### ADDENDUM #3

RE: Solicitation Addendum #3 to RFP #25-01/KVMH Emergency Department Renovation, Phase 3

**EMERGENCY DEPARTMENT RENOVATION**  
 Kauai Veterans Memorial Hospital  
 4643 Waimea Canyon Drive  
 Waimea, Kauai HI 96796

### HGUM

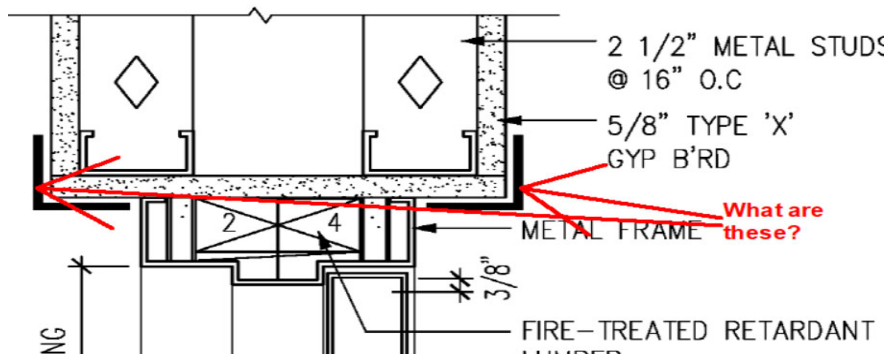
1. Q: Are the B/B/B Units OFCI, OFOI, or CFCI? If so, please provide manufacturer specs. B/B/F can be found on 3/A008.  
A: B/B/F units are Contractor Furnished/Contractor Installed (CFCI). Spec for B/B/F can be found in Section 6B - Finish Carpentry, Paragraph 12.
2. Q: Sheet A011 Details 9 does not provide attachment details for the 4x12 header adjacent CMU. Please provide details and attachment components.  
A: Use Simpson HGUM to connect 4x12 header to existing CMU wall.

Heavy Face-Mount Girder and Beam Hanger for Concrete and Masonry

The HGUM is a face-mount girder hanger for concrete or masonry applications, available with one flange concealed. It installs with Strong-Drive® SDS Heavy-Duty Connector screws and Titen HD® anchors.

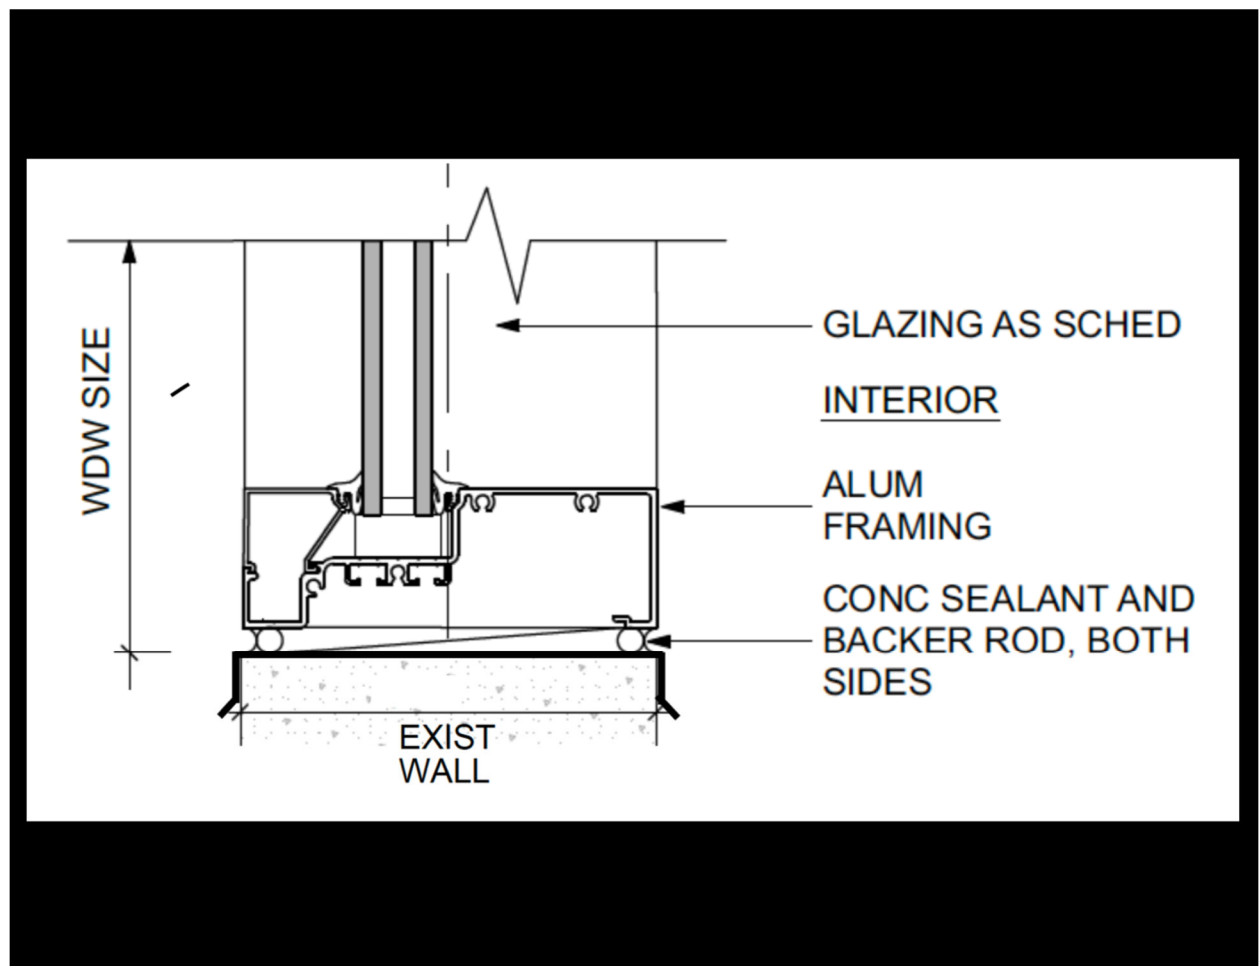
8. Q: Please provide details for the existing window flashing for the existing windows at the waiting room/lobby.

A: [Detail as shown below.](#)

TYPE: 5106-1, S0-SX-SX-S0, BI-PART  
PAGE 51-2.06

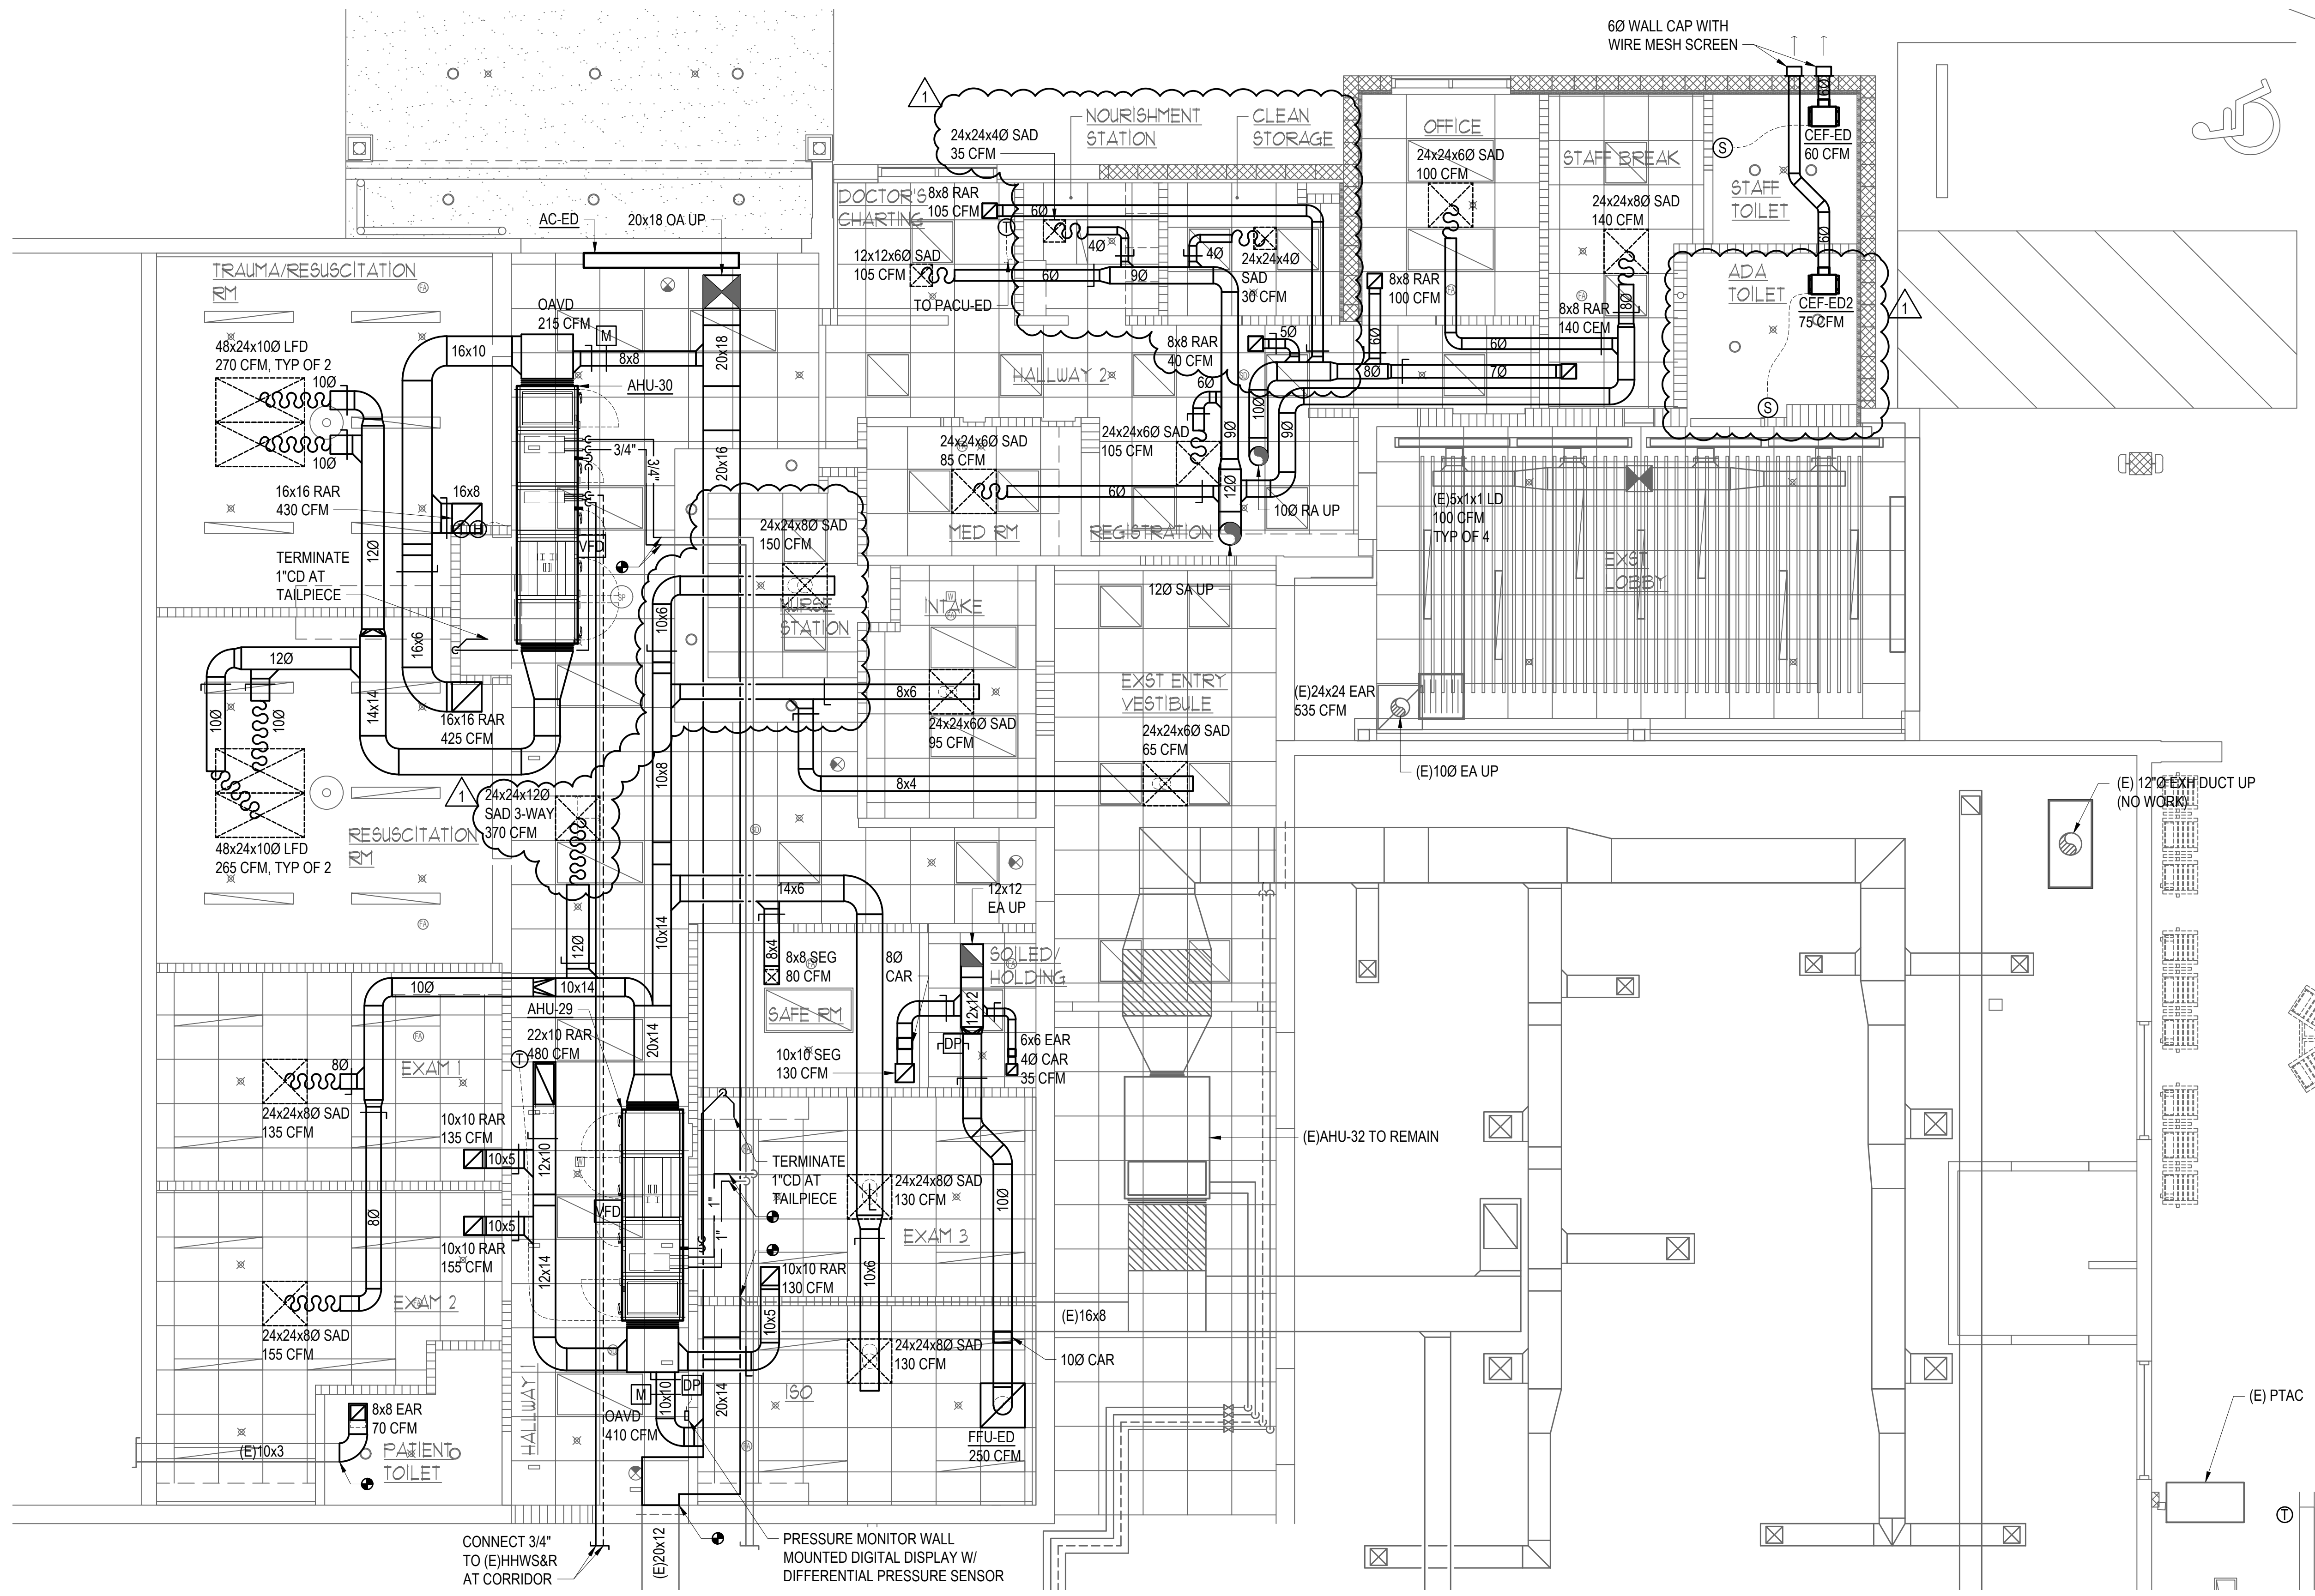
3. Q: What size jamb is the intended for D13 door?  
A: Jamb is provided with Door D/13. See attached Record USA 5106-1 Catalog Cut.
4. Q: Please advise to what these are. This occurs only at doors D1, D9 and D15. Shown on A011 detail 5.

1 MECHANICAL RENOVATION PLAN  
 SCALE: 1/4" = 1'-0"  
 1/4" = 1'-0" 0 1 2 3 4 6 8 12  
 NORTH

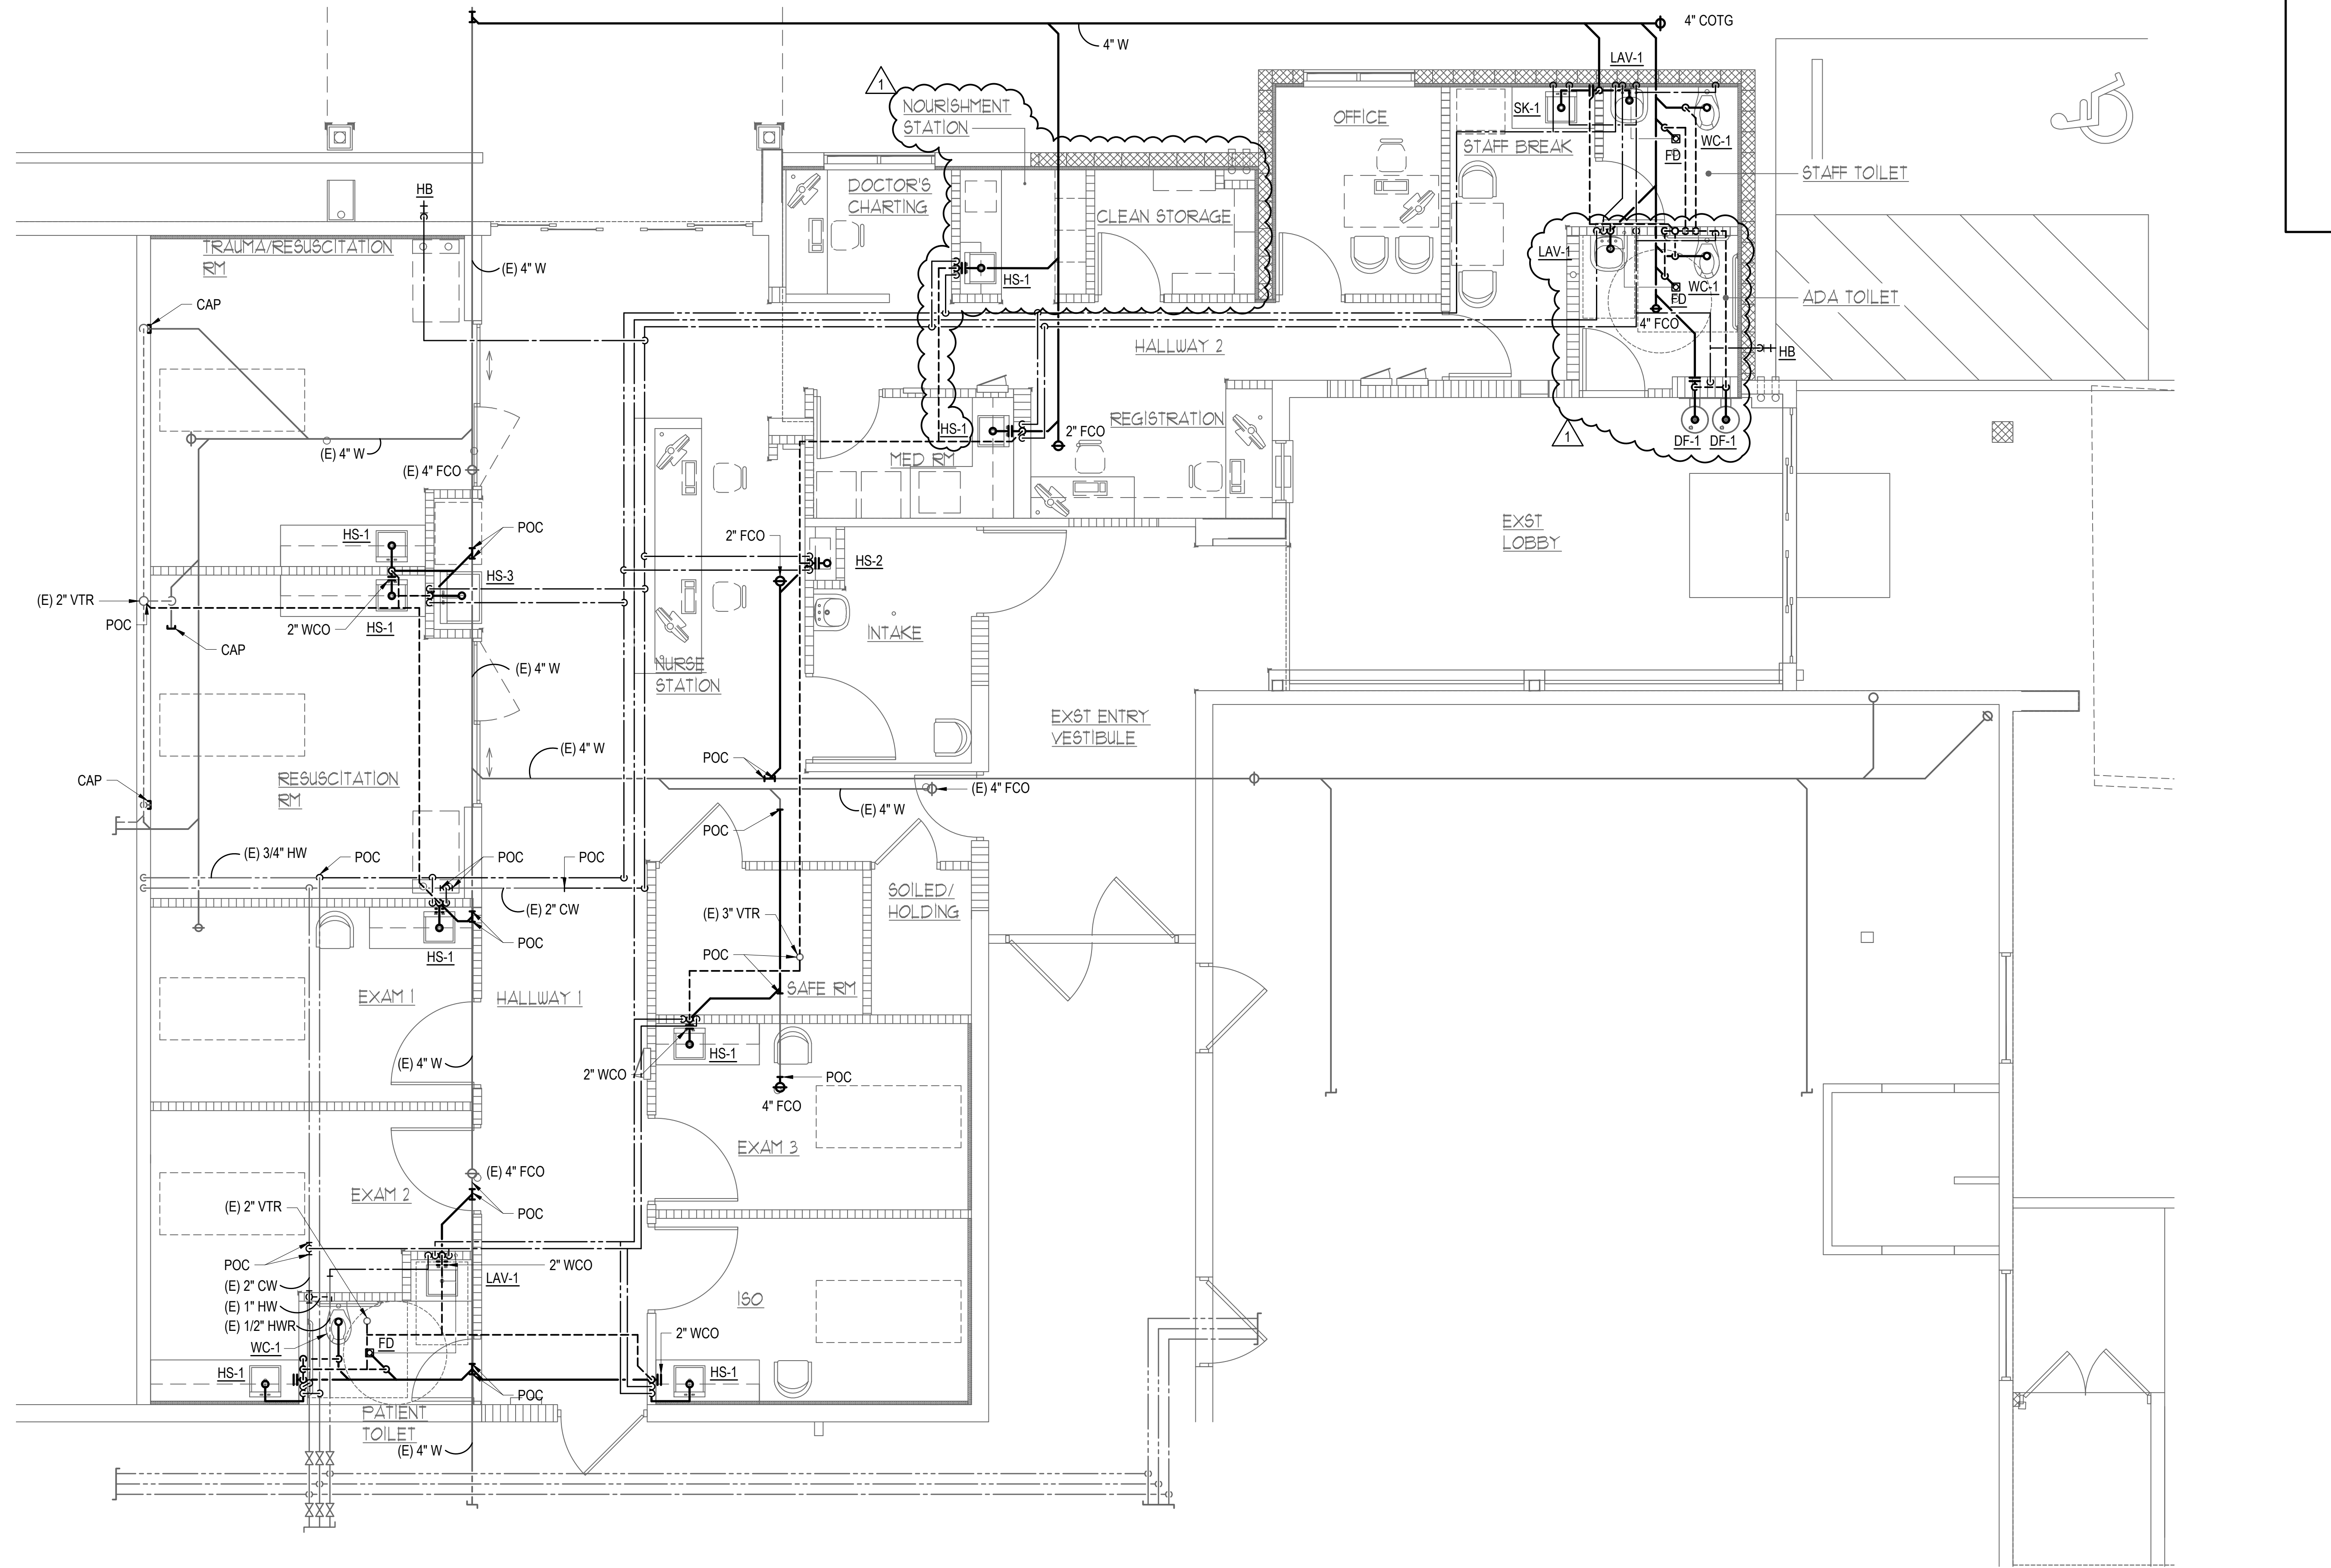
7. Q: Architectural sheet A003 New Floor Plan at Nourishment Station shows a sink. Plumbing sheet M011 Partial Plumbing Plan shows no sink and room is called 'Clean Storage'. Sheet A003 shows 2 rooms in that location: Nourishment Station and Clean Storage. The same layout discrepancy occurs in the Mechanical Renovation Plan (M009), Med Gas Plan (M012), and Fire Sprinkler Plan (M013). Please advise as to which floor plan is the correct one.

A: [Please refer to revised Mechanical Plans attached.](#)
